STAFF COMMENTS FOR PLANNING COMMISSION

SITE PLAN: SP-07-0001

**TITLE: ASBURY METHODIST VILLAGE
NORTH VILLAGE**

**REQUEST: CONCEPT/PRELIMINARY PLAN
APPROVAL**

**ASBURY NORTH VILLAGE
PRELIMINARY SITE PLAN**

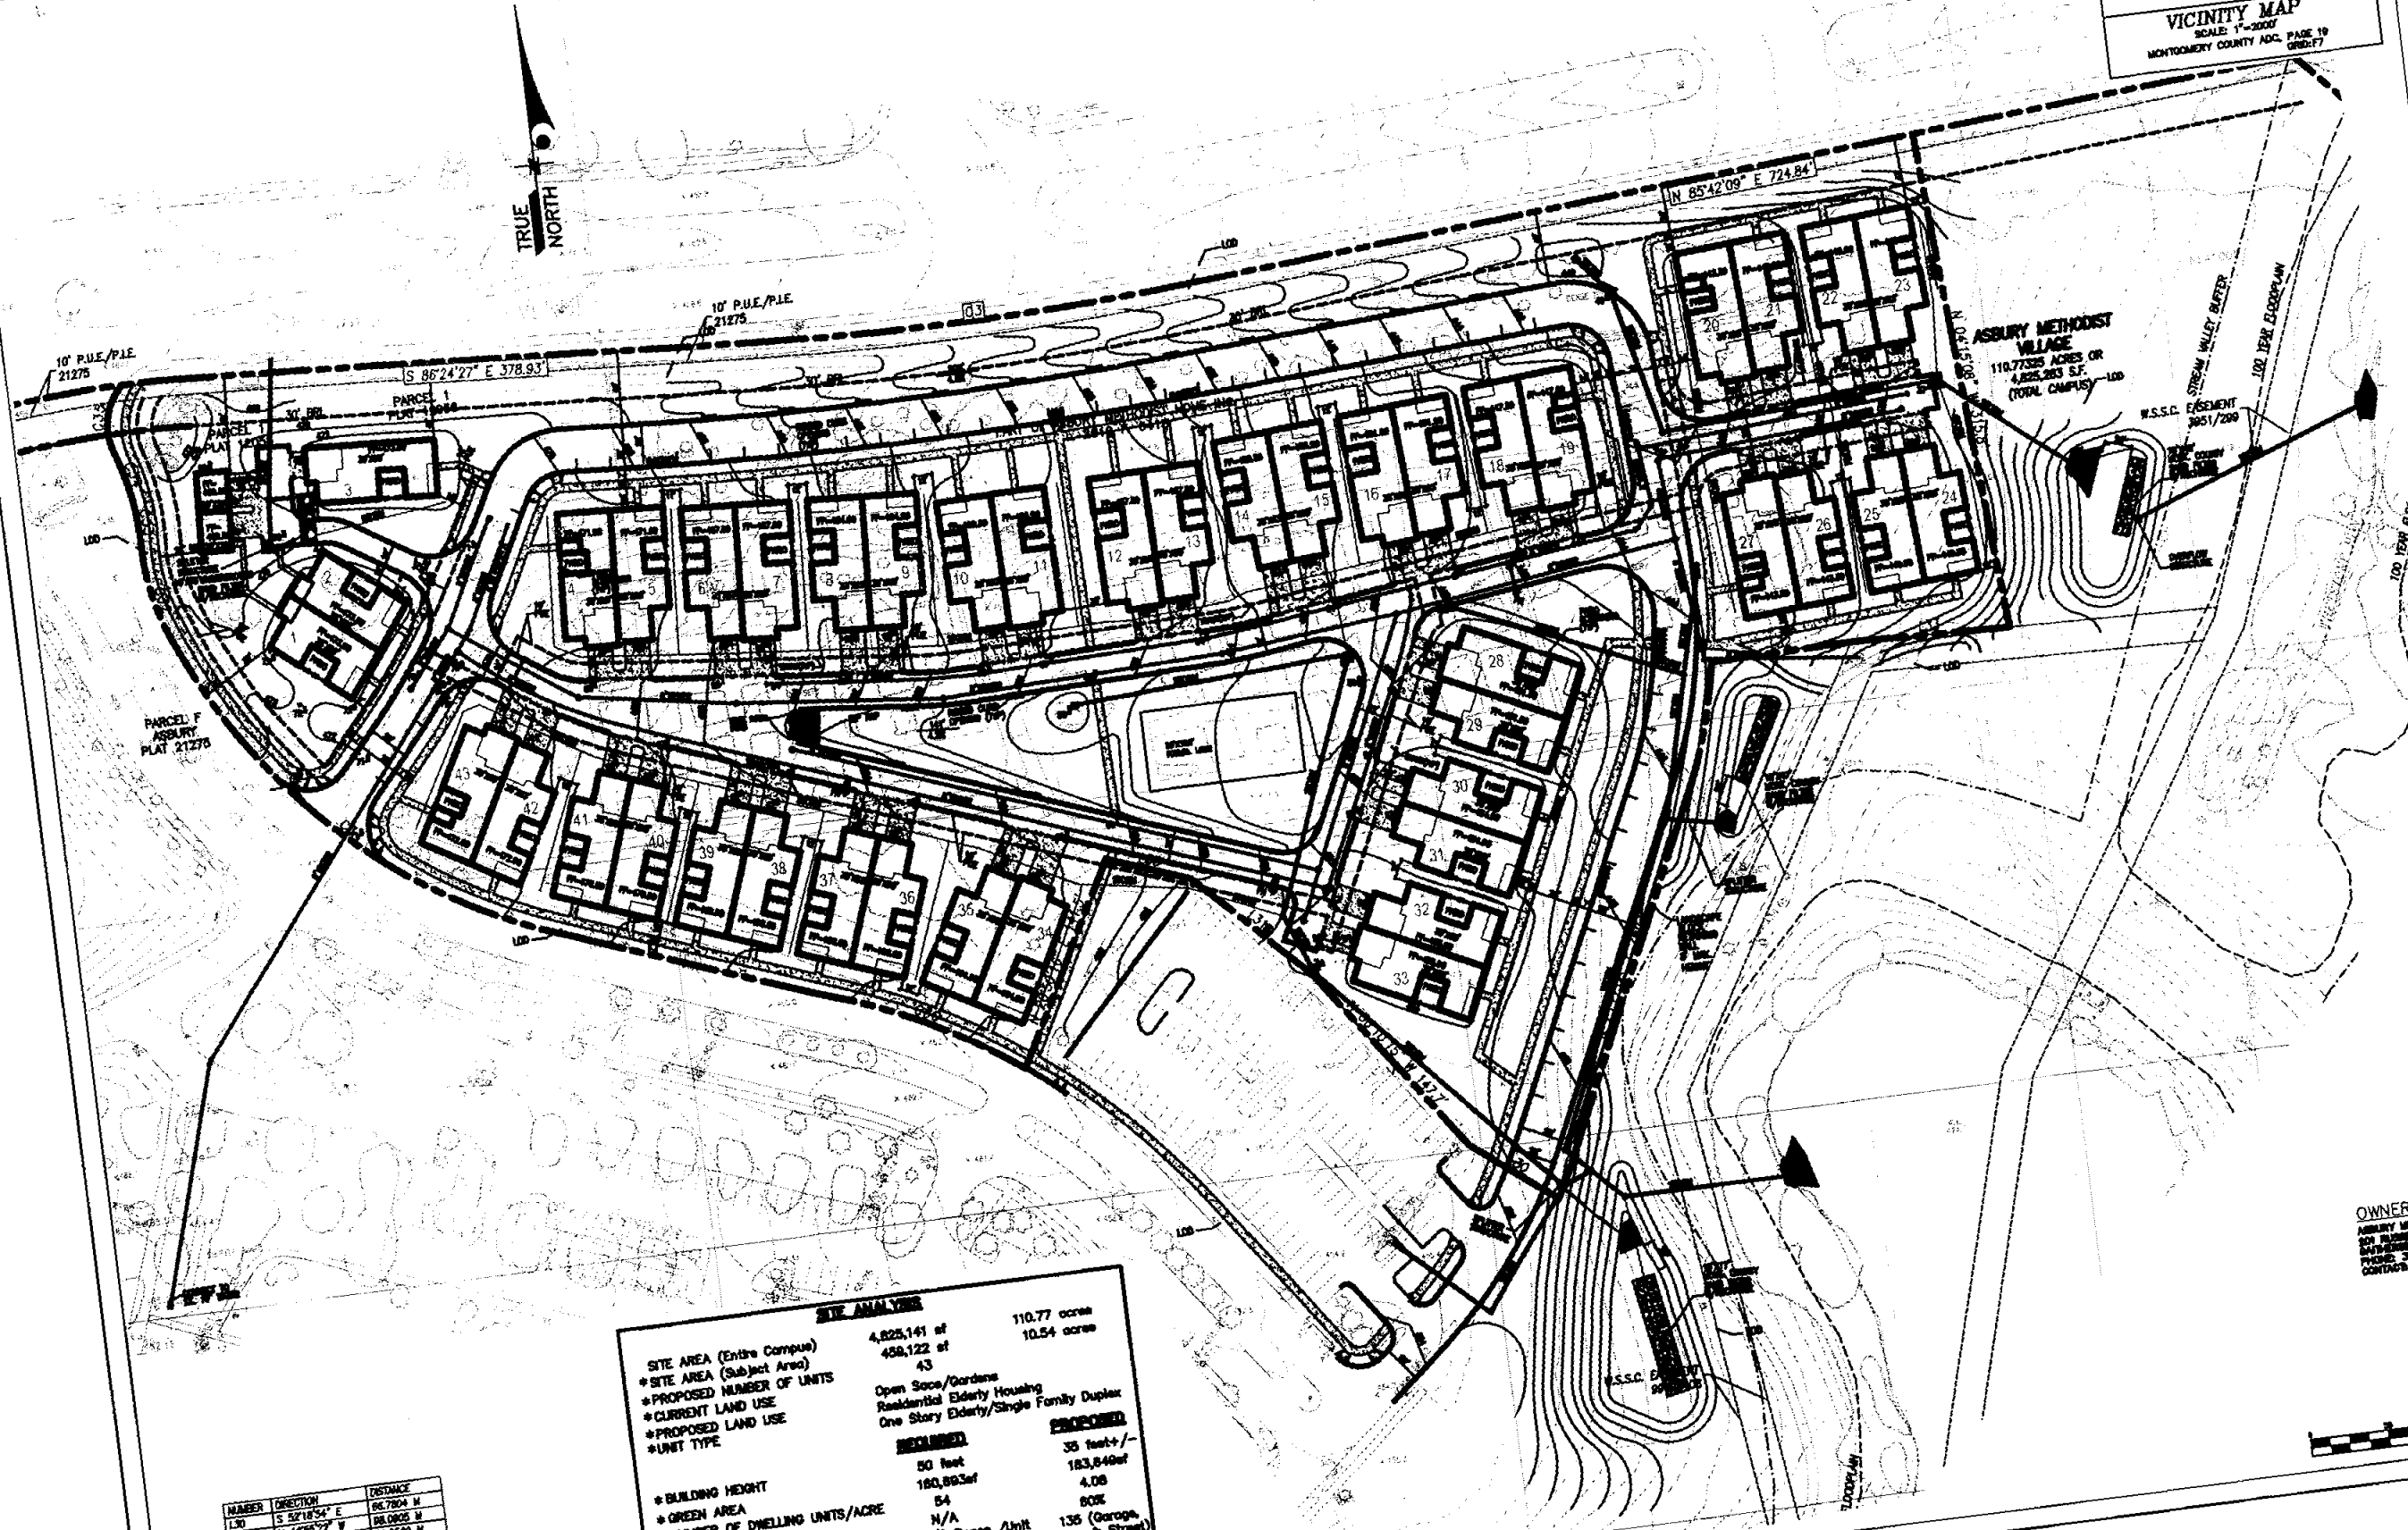
The site plan proposes 43 duplex units on a private street parallel to Odend'hal Avenue and also Asbury Drive (private). See Exhibit #11. The annexation agreement allows 54 units per acre for the campus, but this 10.54 acre site will have a density of 4.08 units per acre. One unit is not attached but its layout is the same as the other units.

This is designed in a neo-traditional manner with sidewalks and lead walks provided to all the units and rear alleys. All but two units, located nearest to the gatehouse, have attached two-car garages with driveway parking. In addition, the perimeter roads are 28 feet wide which will allow two-way traffic and parallel parking on house side of the street. The parking ordinance requires one-half of a parking space per unit (22 spaces) and the applicant knowing that these units are marketed to the more mobile spectrum of their elderly clients is providing a total of 135 parking spaces (garage, driveway and street) or 3 spaces per unit. (This doesn't include the parallel parking on Asbury Drive or the parking lot for the Rosborough Cultural Arts Center.)

the existing Villas located off of Russell Avenue. The lot lines need to be slightly adjusted to match existing parcel lines.

WSSC - A letter (Exhibit #8) was submitted to the City concerning Water and Sewer. In response, the applicant has revised the site plan to tie its utilities into an existing ten inch water line and the existing sewer system that runs parallel to the ponds and stream.

- 6. APPLICANT TO ADJUST LOT LINES TO MATCH EXISTING PARCEL LINES; AND**
- 7. APPLICANT TO PROVIDE TWO ADDITIONAL FIRE HYDRANTS FOR ADEQUATE FIRE SAFETY AT THE TIME OF FINAL SITE PLAN APPROVAL.**

Conceptual Elevations

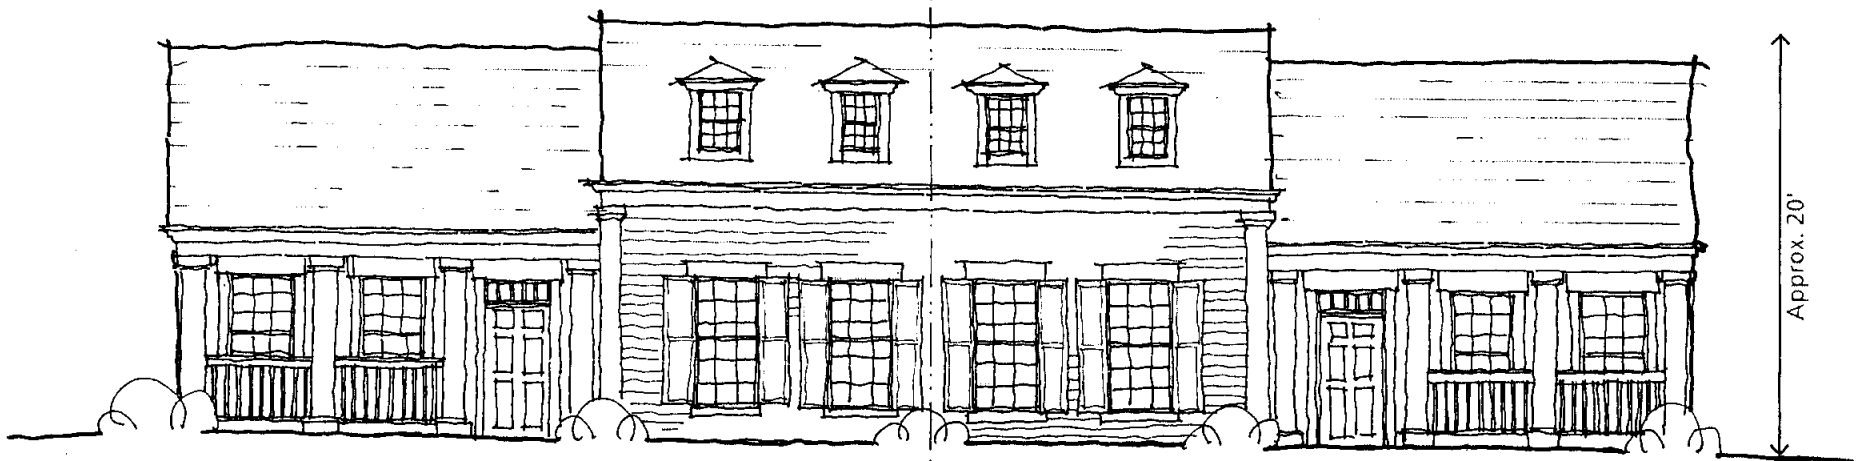
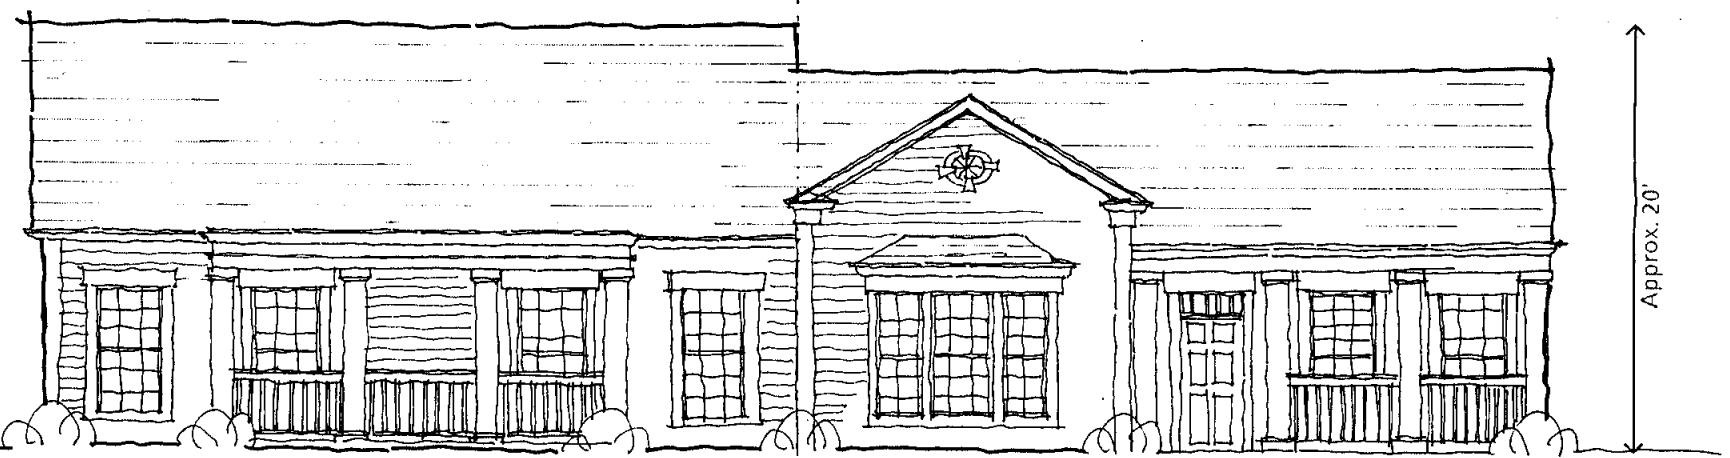
Conceptual front one-story elevations have been submitted by the applicant (Exhibit # 13). These show three different elevations including one with a side entry (Elevation

C). Although not identified, the materials are to be cementitious siding with brick on some of the corner units, which will be shown at Final Site Plan review. The dormer windows on the second level are not usable windows. The buildings are twenty feet in height to the ridge of the roof.
